3 Detailed description of change

Product Change Notification							1062 Power Entry Module	
owner	creation date	release date	released by	change order no	rev	page	D10-034-451	
sariogar	01.03.2019	02.04.2019	limachcl	2017224	A	1 of 3

Old product appearance	New product appearance
<p style="text-align: center;">Front side</p>  <p style="text-align: center;">Back side</p> 	<p style="text-align: center;">Front side</p>  <p style="text-align: center;">Back side</p>

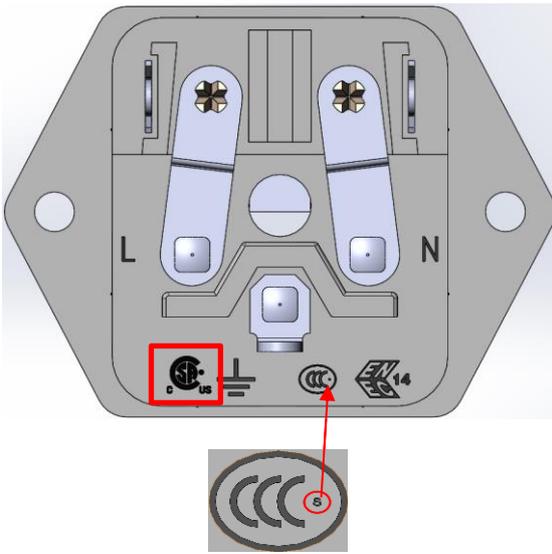
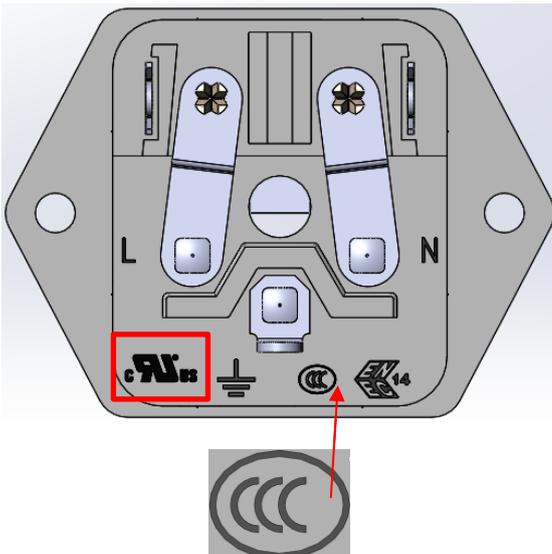
- Change of approval marks on the product
- Change of approval marks on the packaging label

- Standards update according to the new UL/CSA 60320-1
- Simplification of compulsory CCC mark

Old product appearance	New product appearance
Part numbers with different back side: 4304.6145, 4304.6151, 4304.6180

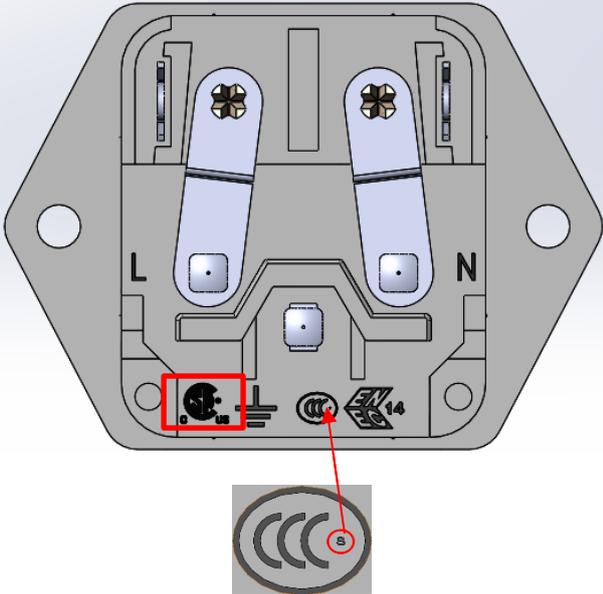
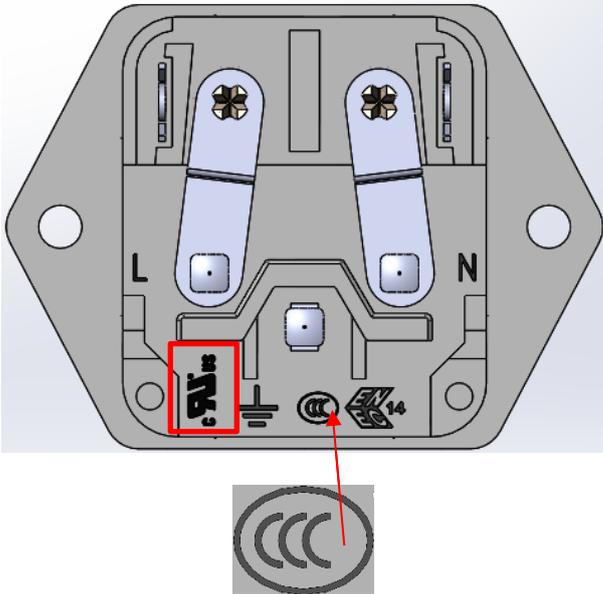
Please note that only screw mounting types are illustrated. However, the same changes apply to both mounting types with screw flange and snap-in as listed in the affected part numbers list in chapter 1.
